ADDENDUM 1

August 3, 2023

Carthage Flats
7020 Vine Street
Cincinnati, OH 45216

Emboss Design (formerly PCA)
906 Monmouth Street
Newport, KY 41071

JOB NO.
SHEET NO.
C-02

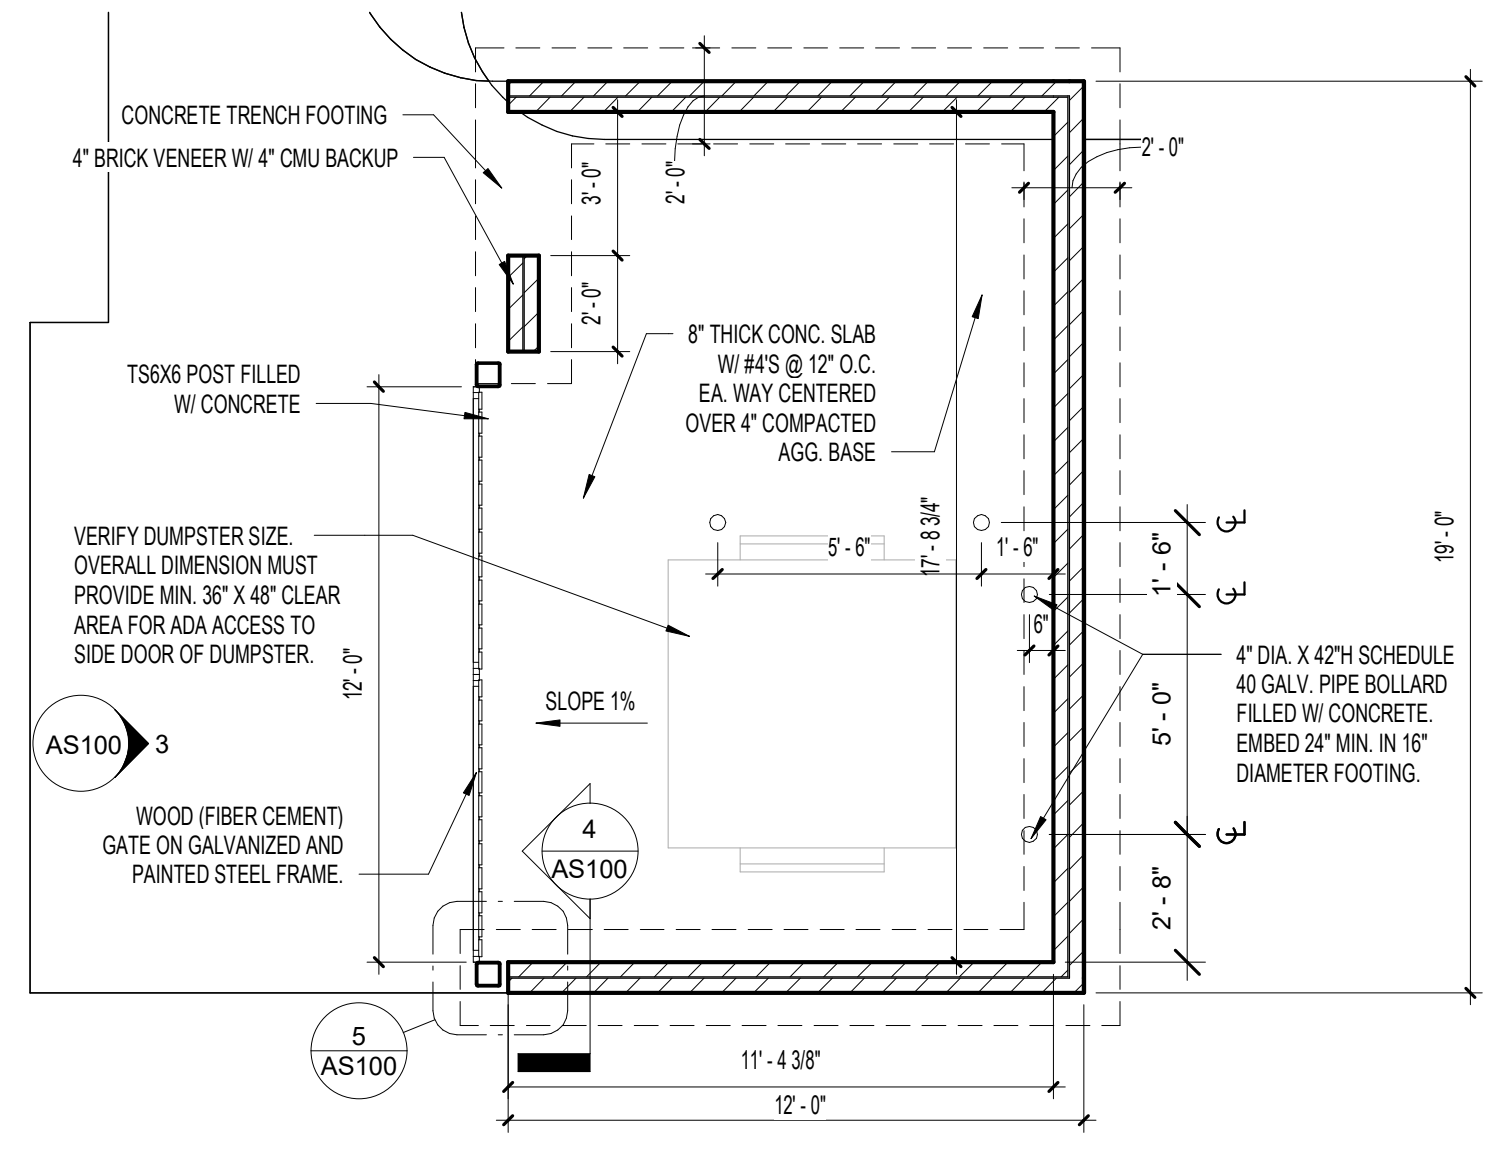
- Revised shape of the kids area and picnic area.
- Revised location of outdoor pavilion.
- Added 7' tall fence – sound wall.

4. AS101 SITE DETAILS

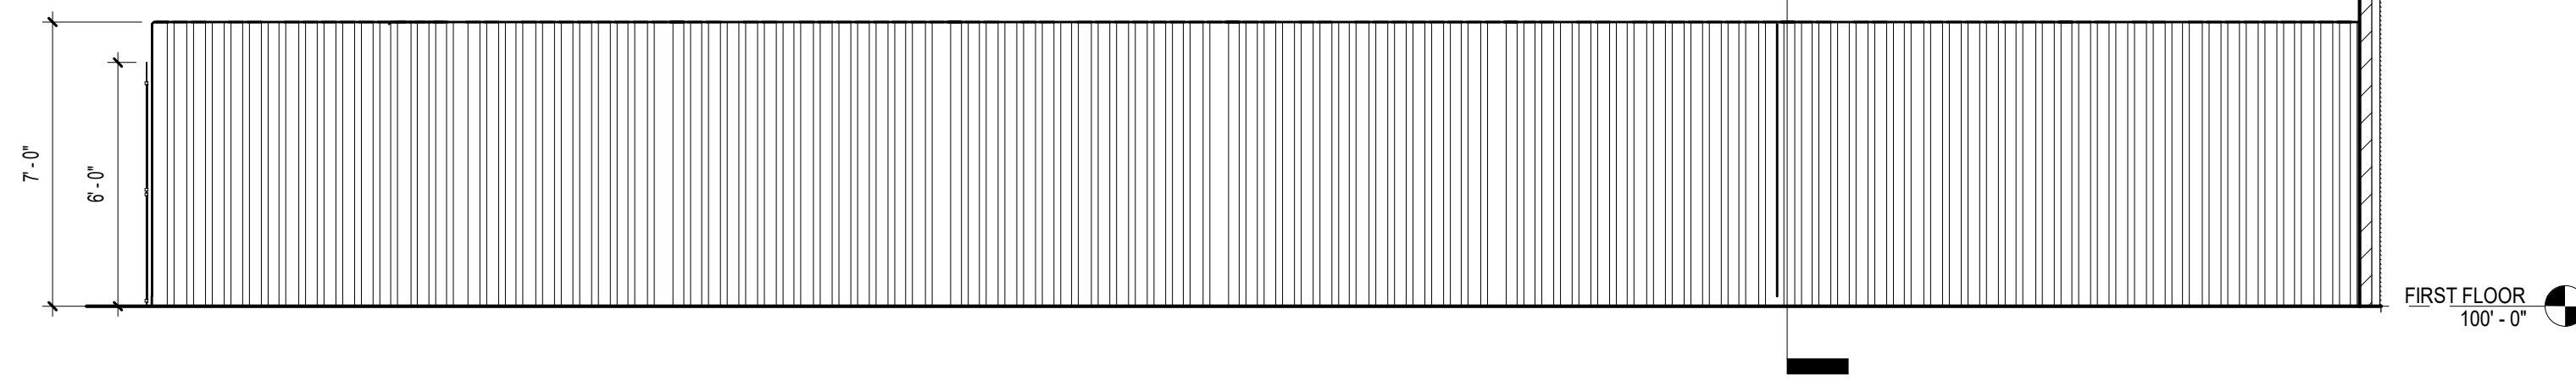
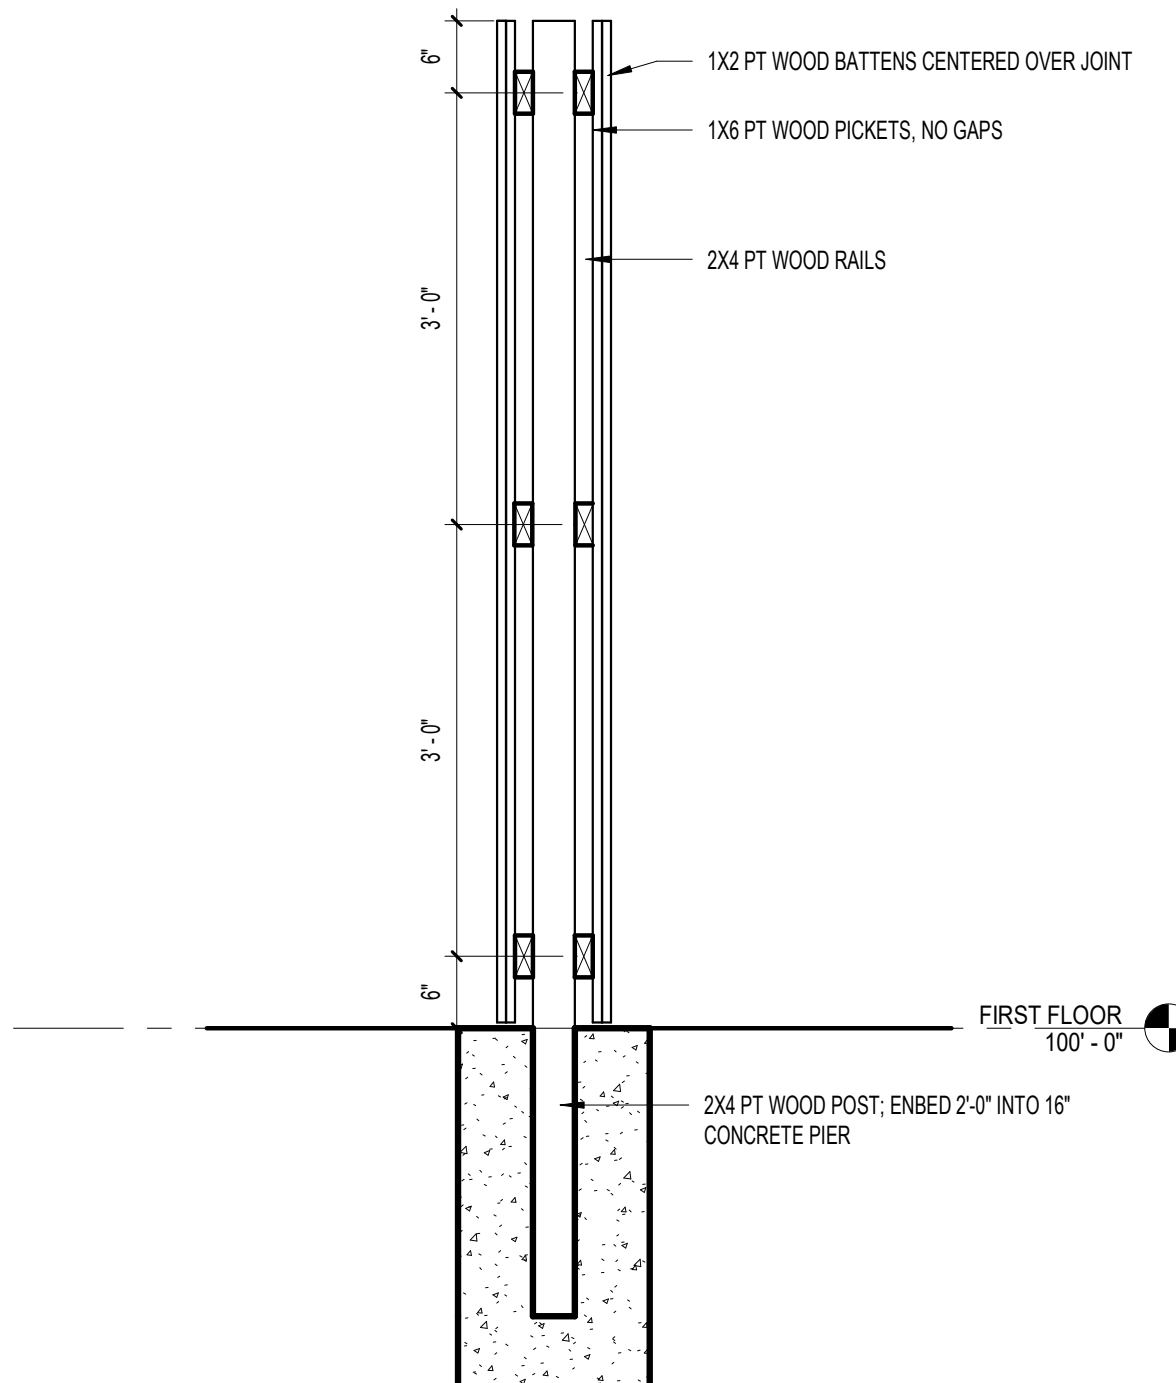
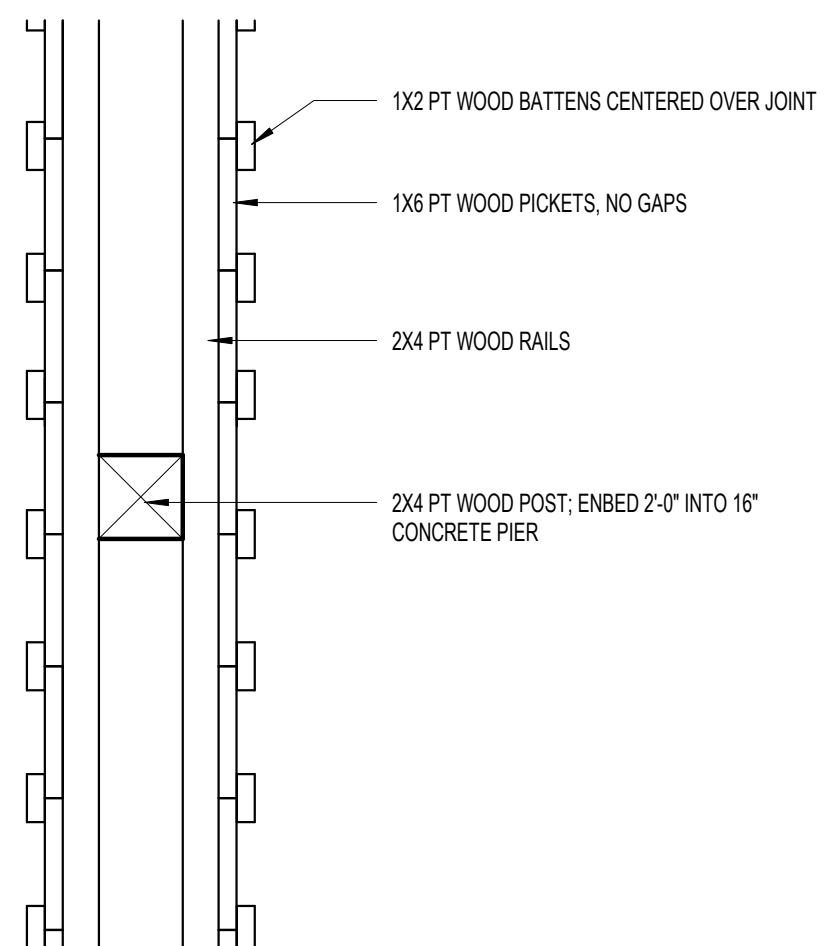
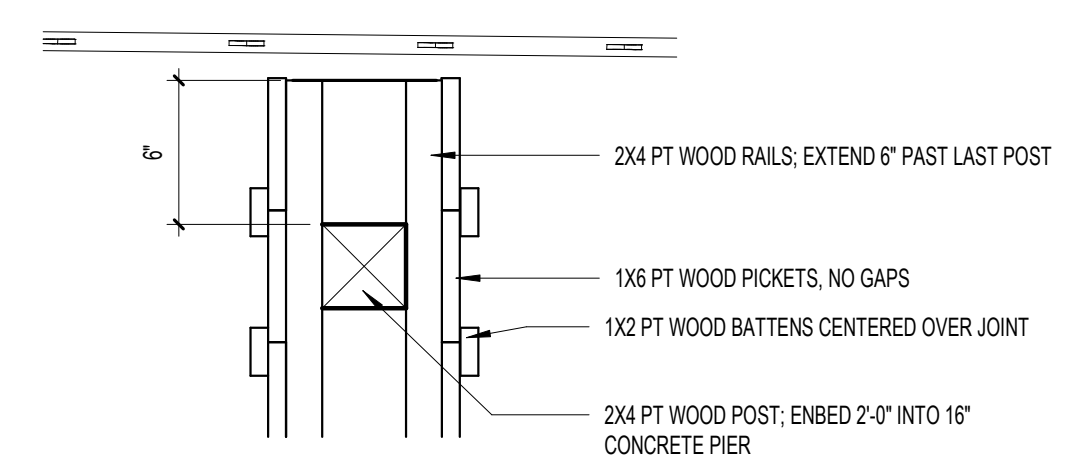
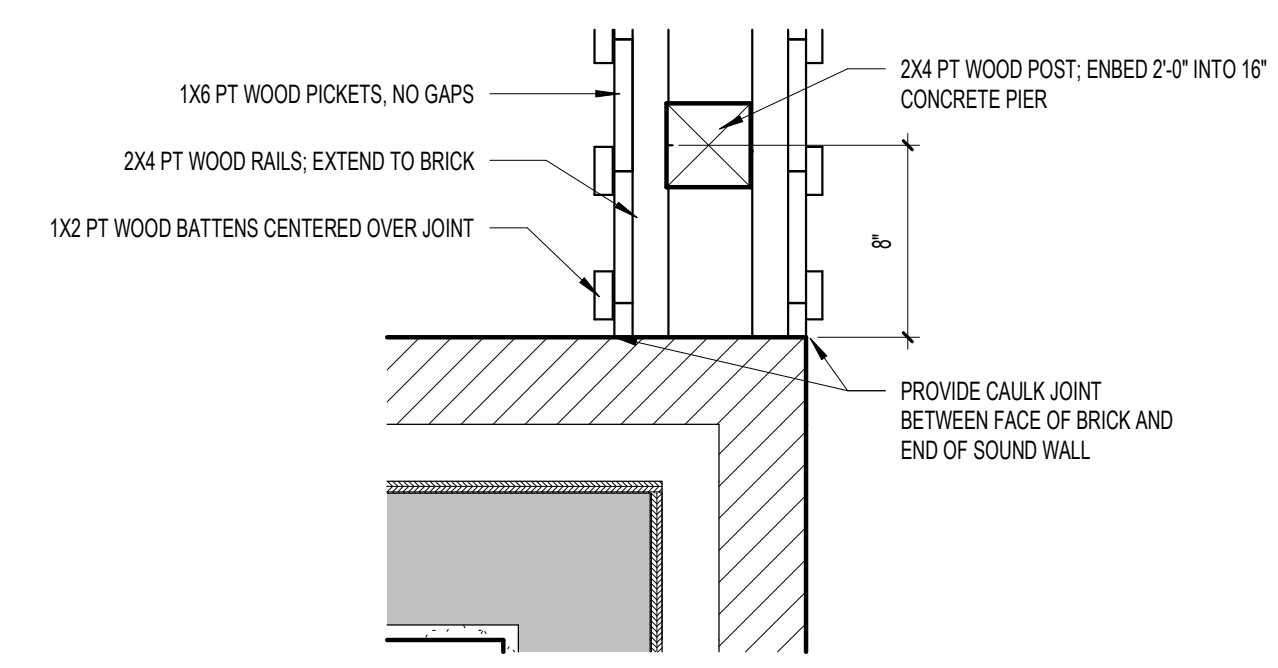
- New sheet with the enlarged plan, elevation, section and plan details describing the sound wall.
